Local Planning Panel

Address: 117 Victoria Street, Potts Point

Application Number: D/2024/524

Proposal

southern elevation – built to boundary basement shown in orange

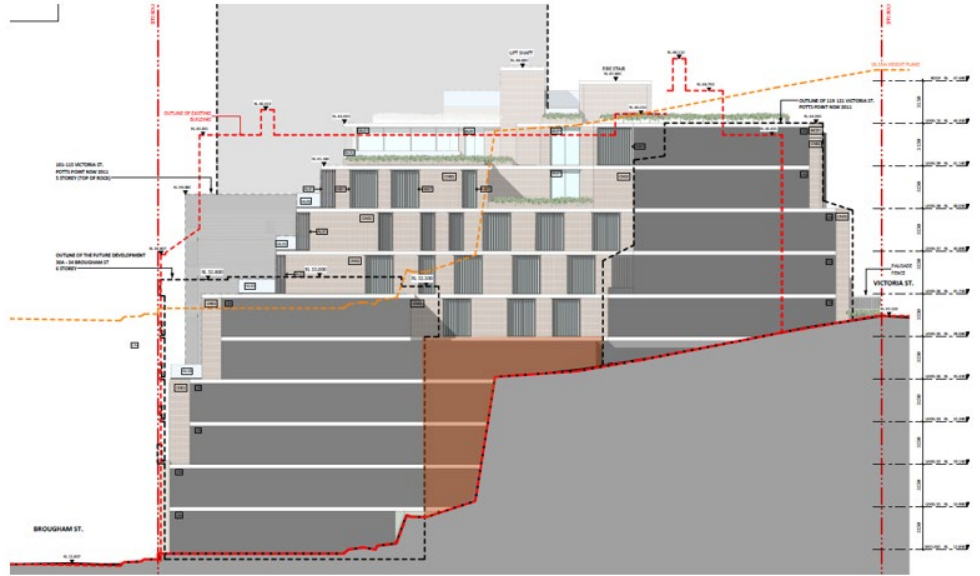
- inadequate building separation and setbacks
- insufficient information to assess efficacy of screening to side elevations
- basement walls built to boundary
